**Lee Nuclear Station Units 1 and 2
Description, Scope of Changes, and FSAR Impacts due to Plant Relocation and
Additional Design Enhancements**

**Description and Rationale for Lee Nuclear Station Units 1 and 2 Relocation and
Additional Design Enhancements**

FIGURE 2.4.3-228

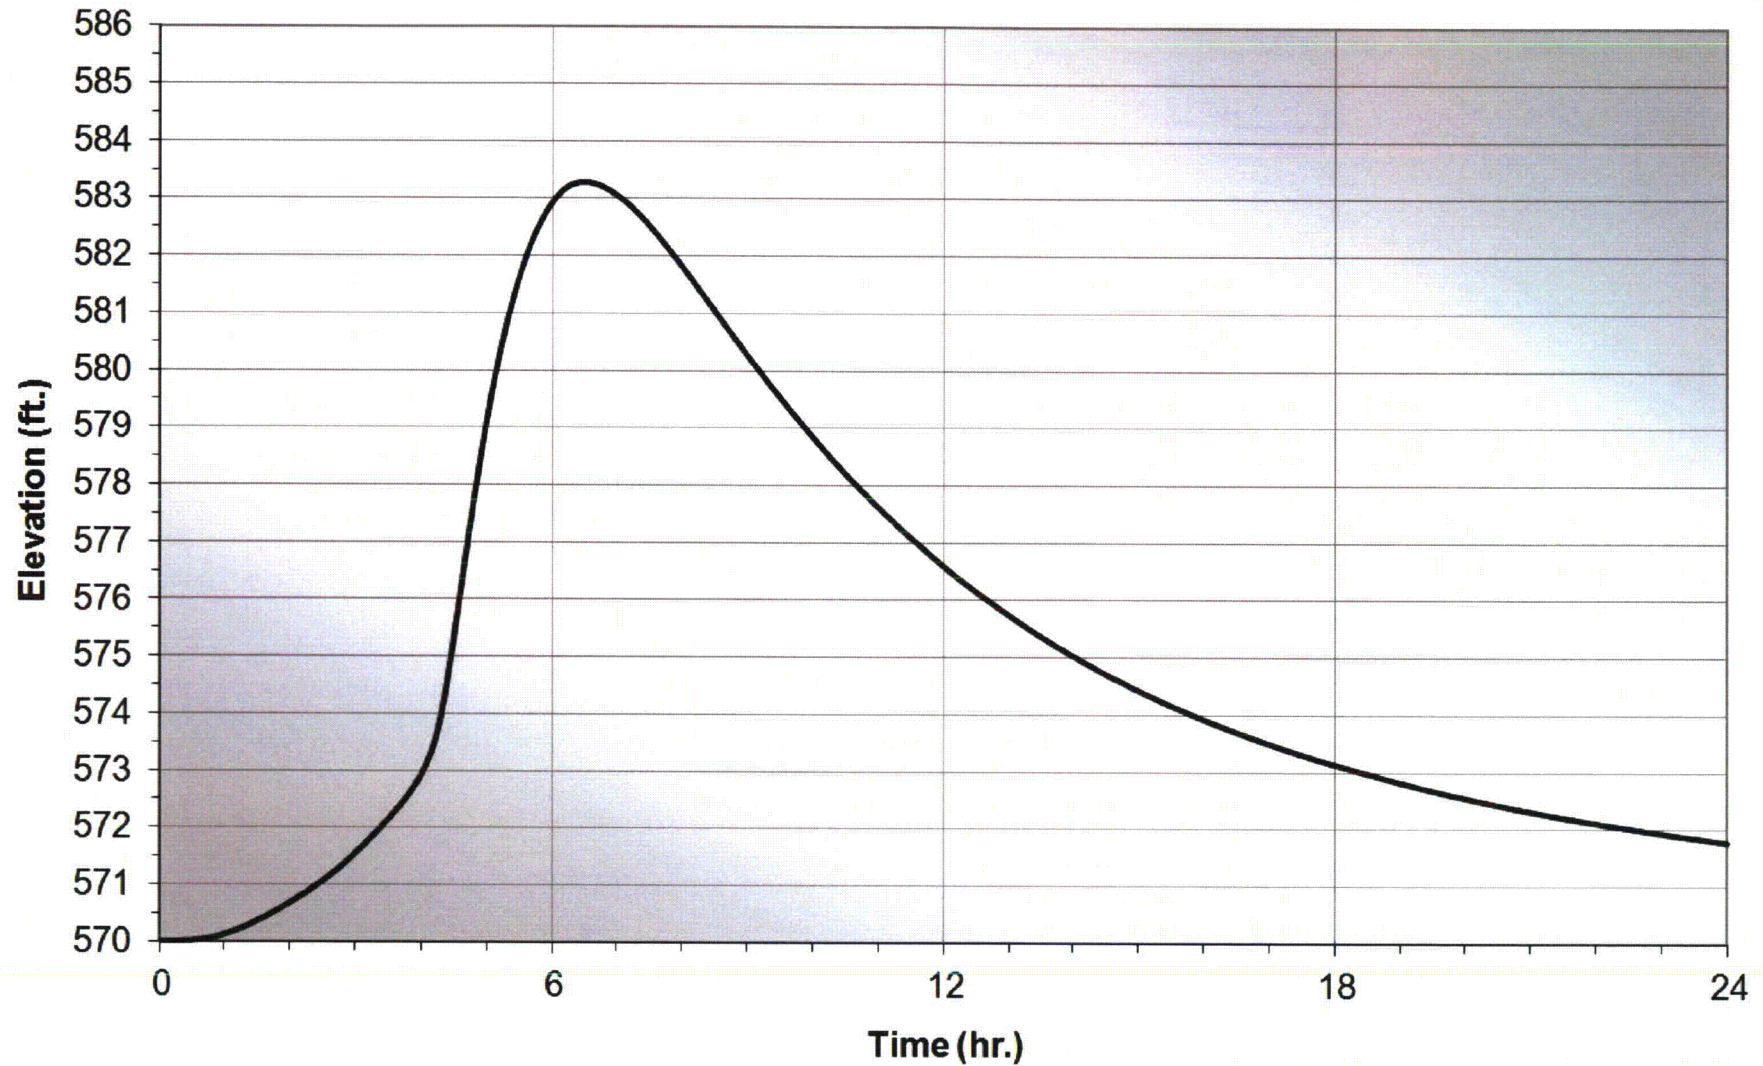
50. COLA Part 2, FSAR Chapter 2, Figure 2.4.3-228 is revised as follows:

FIGURE 2.4.3-230

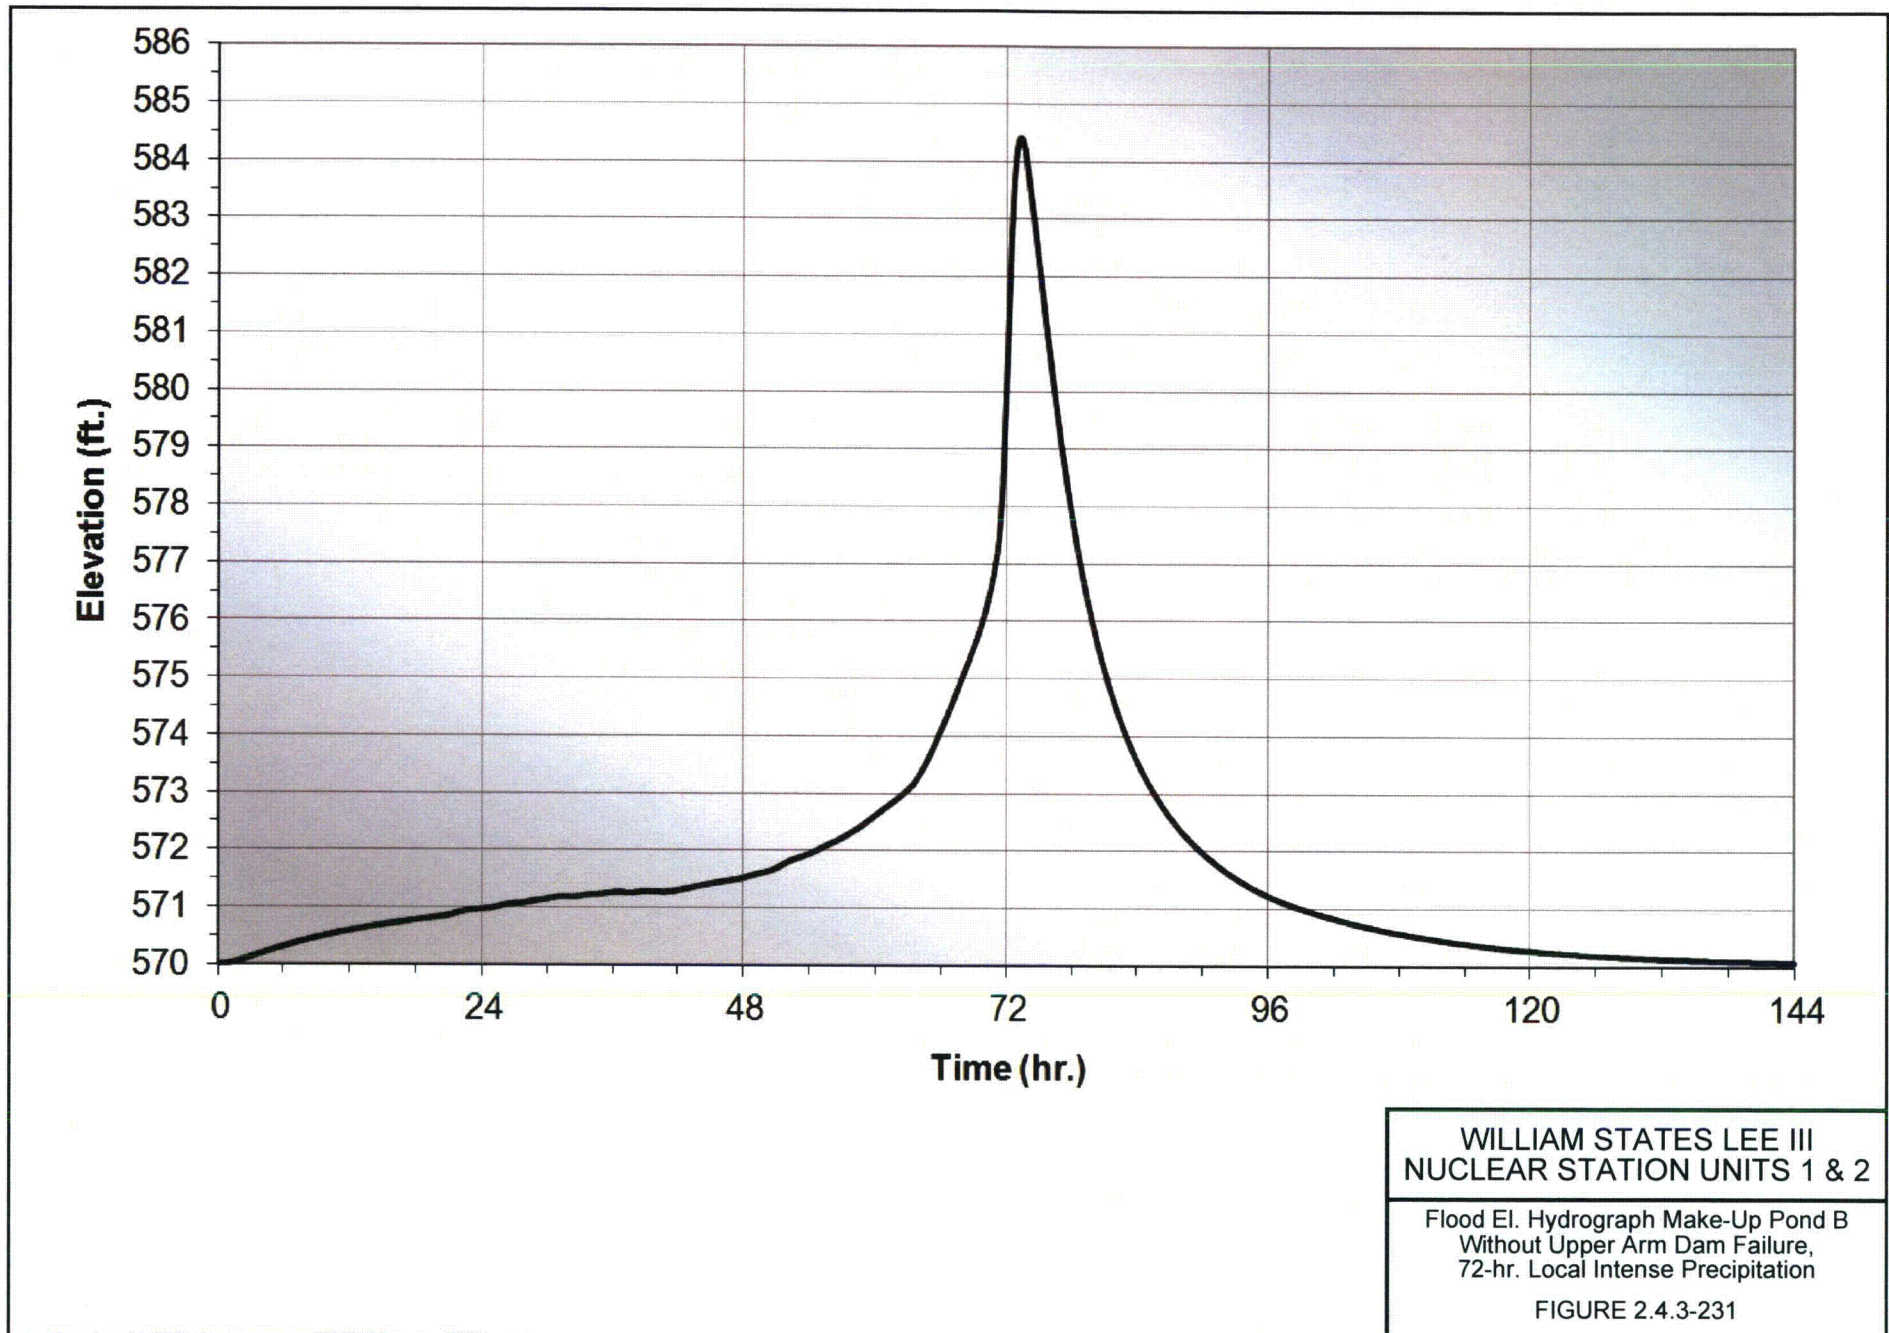
51. COLA Part 2, FSAR Chapter 2, Figure 2.4.3-230 is revised as follows:

FIGURE 2.4.3-233

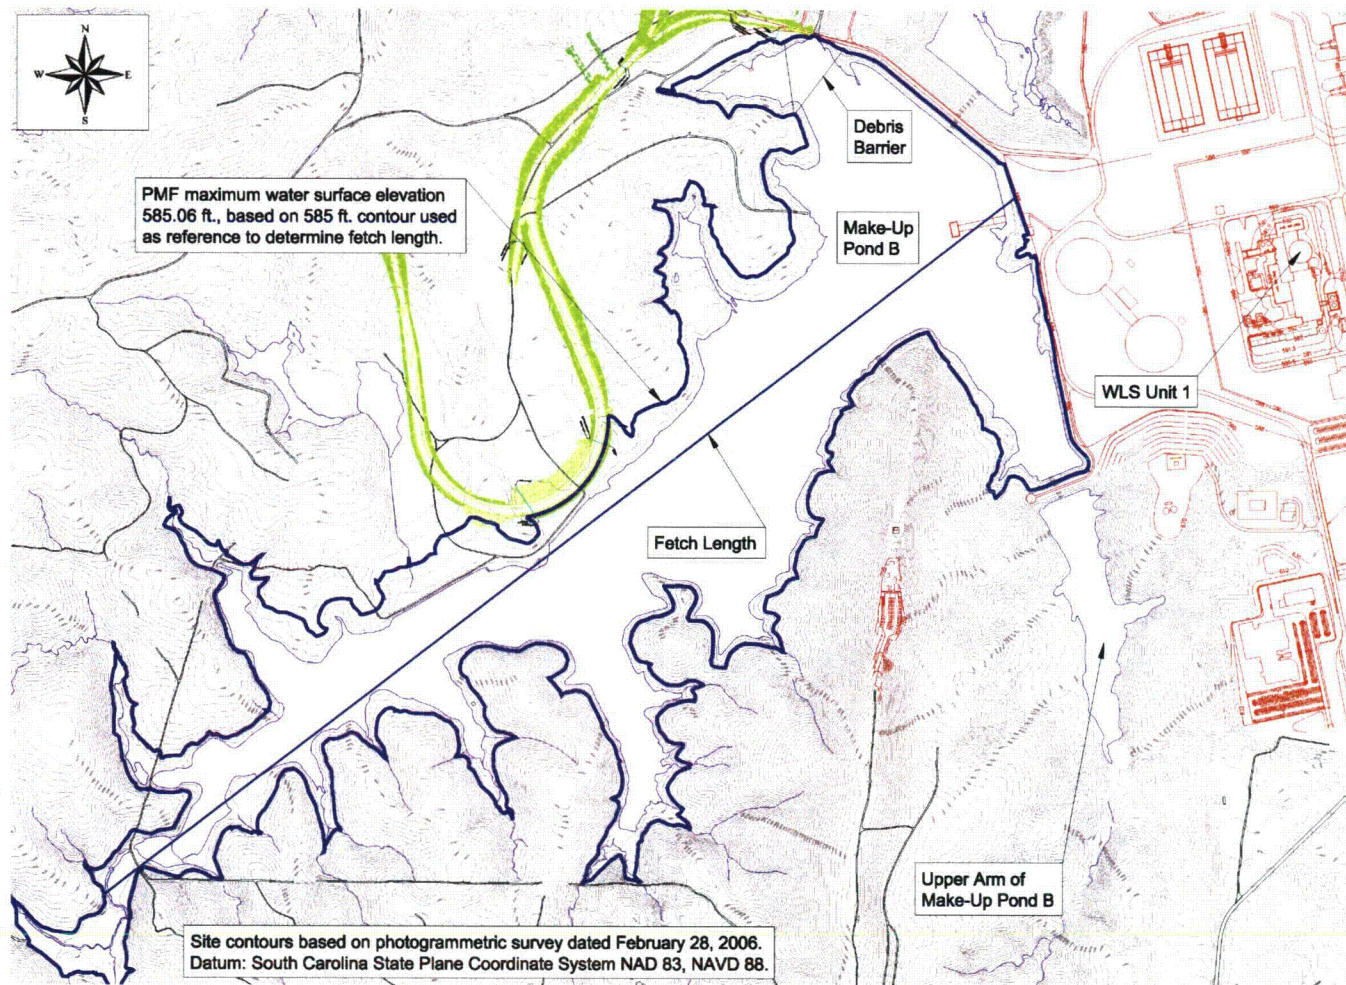
53. COLA Part 2, FSAR Chapter 2, Figure 2.4.3-233 is revised as follows:

FIGURE 2.4.3-234

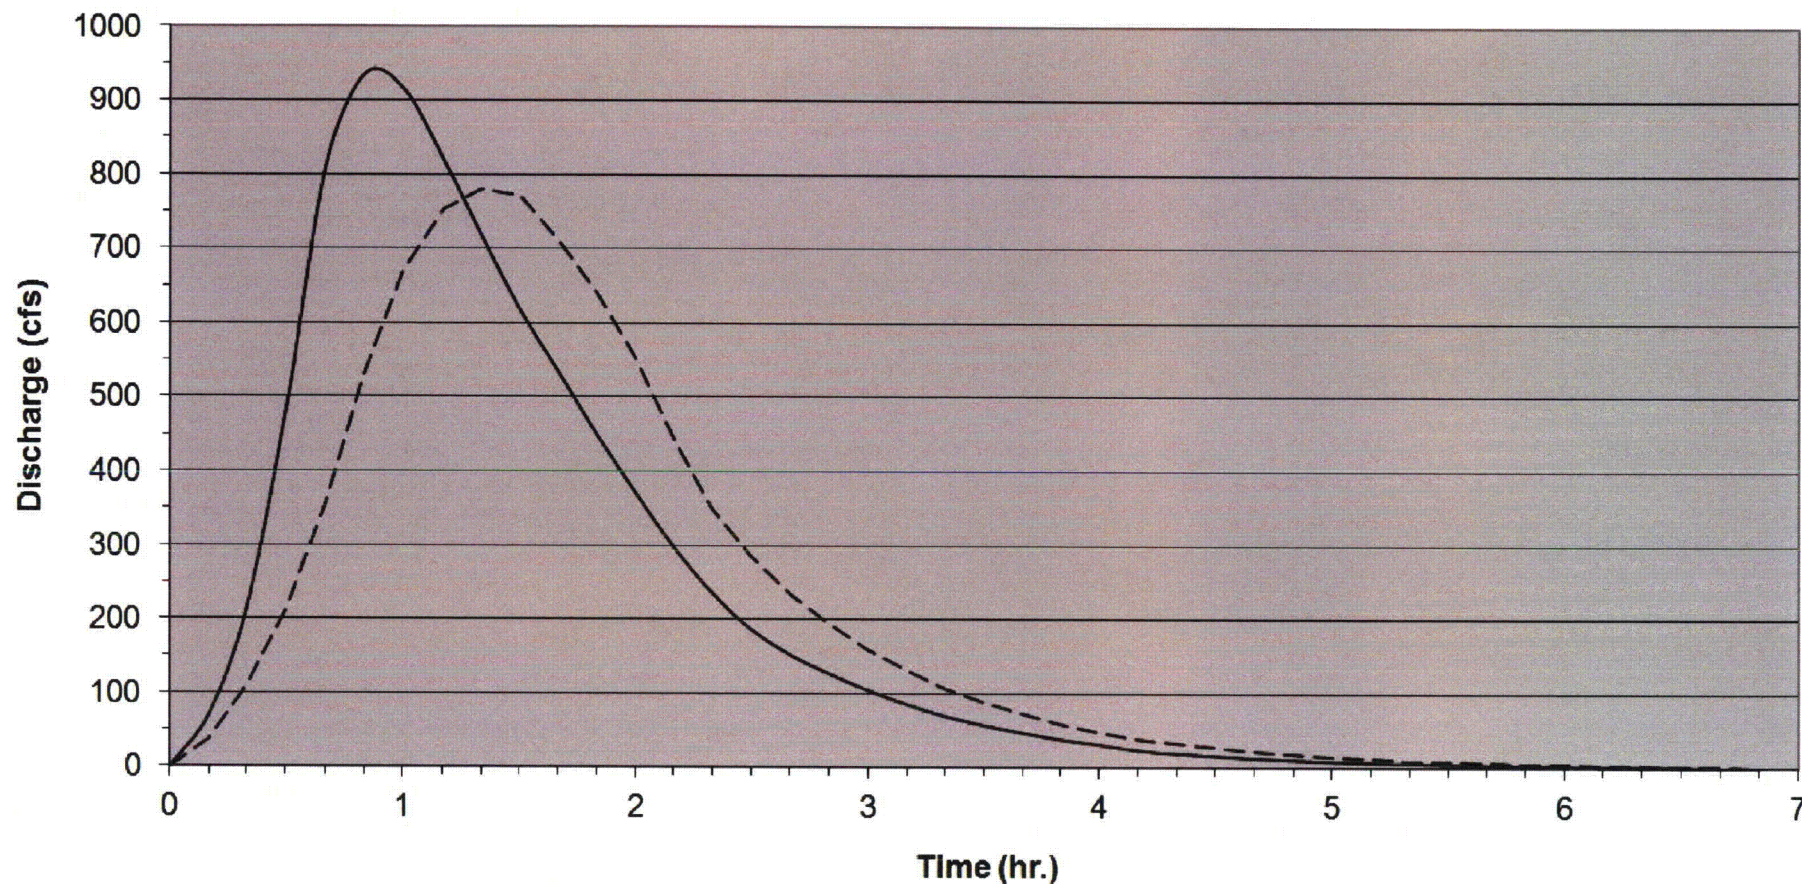
Wind wave activity on Make-Up Pond B is evaluated coincident with the maximum water surface elevation of the PMF including the effects of dam failure, as discussed above. The determined critical fetch length of 4.471.39 mi. is shown in Figure 2.4.3-234. The 2-year annual extreme mile wind speed is adjusted based on the factors of fetch length, level overland or over water, critical duration, and stability. The critical duration is approximately 35 min. The adjusted wind speed is 50.33 mph.

54. COLA Part 2, FSAR Chapter 2, Figure 2.4.3-234 is revised as follows:

FIGURE 2.4.3-237

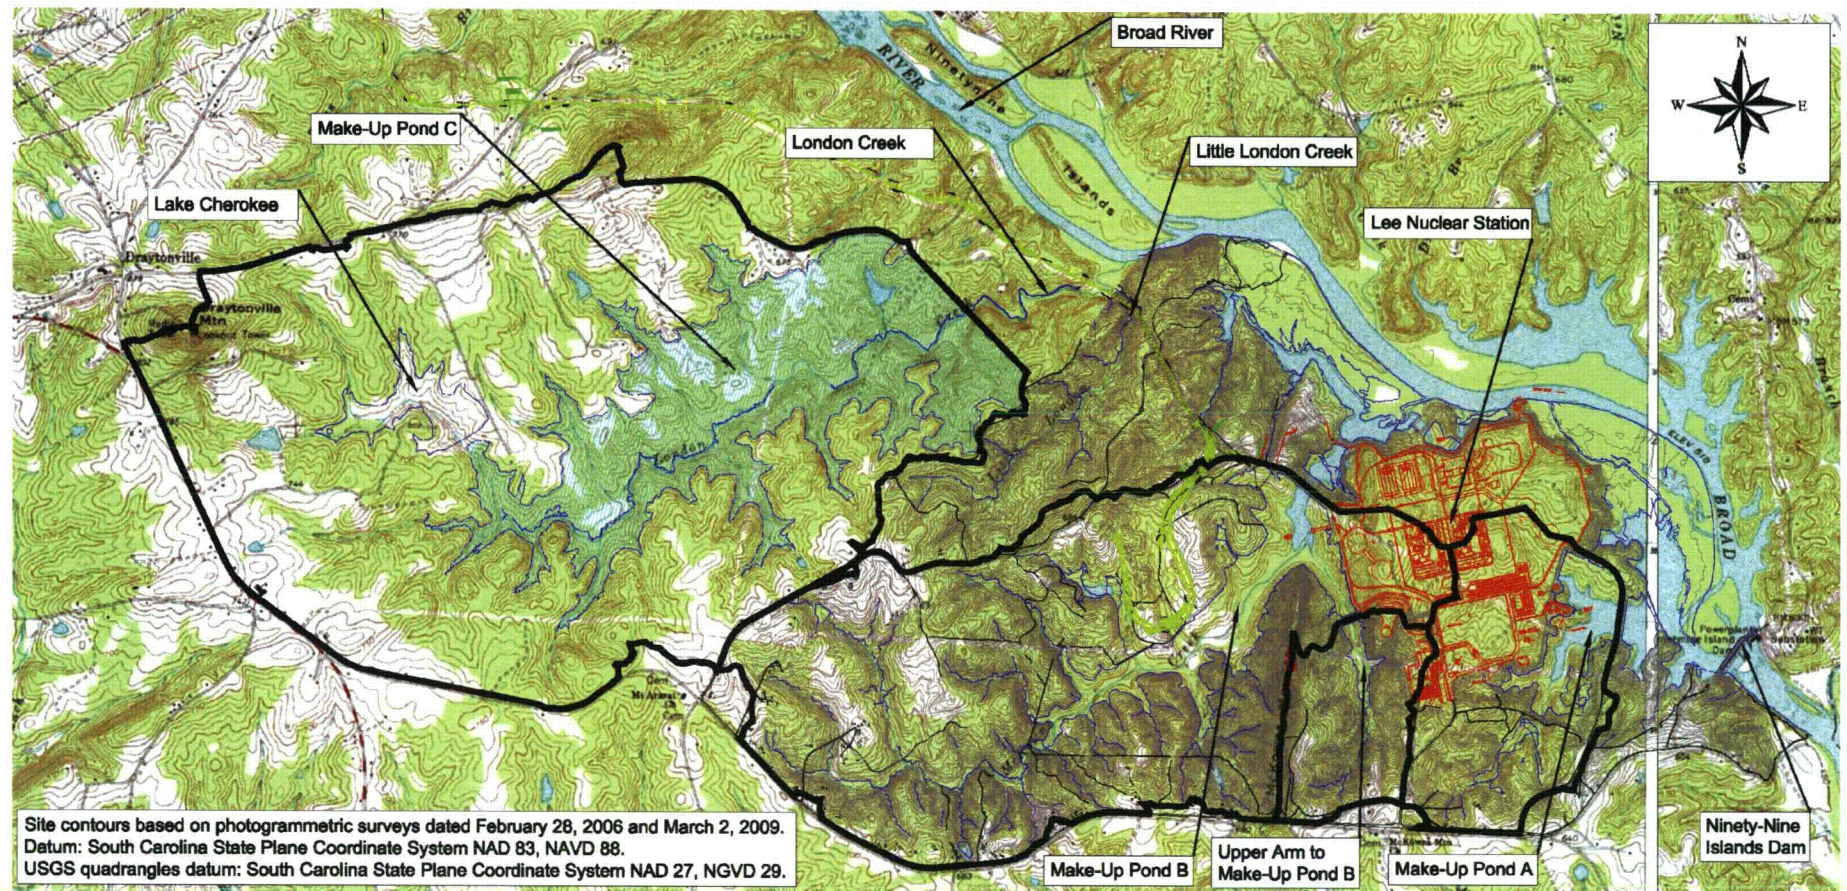
The best calibration of the modified SCS unit hydrograph with the initial SCS unit hydrograph was found using a 10-min. computational time step in Make-Up Pond B in the HEC-HMS modeling software. Therefore, the time step used to define the ordinates of the modified SCS unit hydrograph is also 10 min. The Make-Up Pond B subbasin has a lag time of ~~77~~76.8 min. The initial SCS unit hydrograph and modified unit hydrograph to account for the effects of nonlinear basin response are provided in Figure 2.4.3-237. The modified SCS unit hydrograph is tabulated in Table 2.4.3-208.

55. COLA Part 2, FSAR Chapter 2, Figure 2.4.3-237 is revised as follows:

FIGURE 2.4.3-246

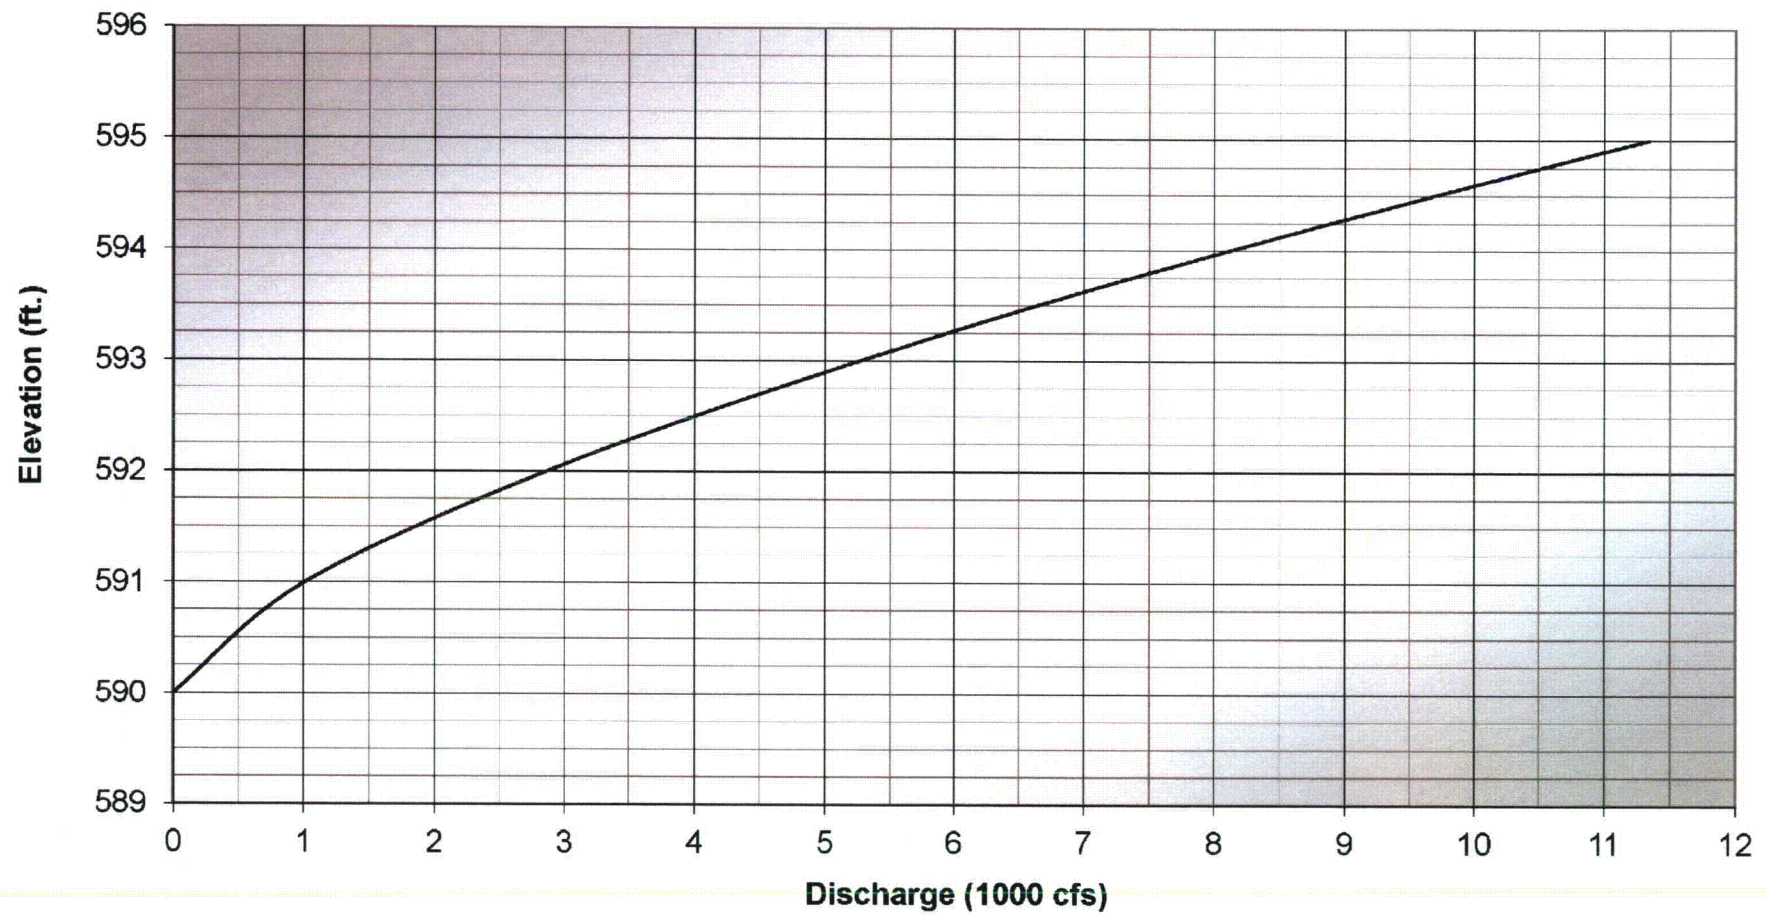
The best calibration of the modified SCS unit hydrograph with the initial SCS unit hydrograph was found using a 2-min. computational time step in the Upper Arm watershed in the HEC-HMS modeling software. Therefore, the time step used to define the ordinates of the modified SCS unit hydrograph is also 2 min. The Upper Arm subbasin has a lag time of ~~46~~16.2 min. The initial SCS unit hydrograph and modified unit hydrograph to account for the effects of nonlinear basin response are provided in Figure 2.4.3-246. The modified SCS unit hydrograph is tabulated in Table 2.4.3-209.

57. COLA Part 2, FSAR Chapter 2, Figure 2.4.3-246 is revised as follows:
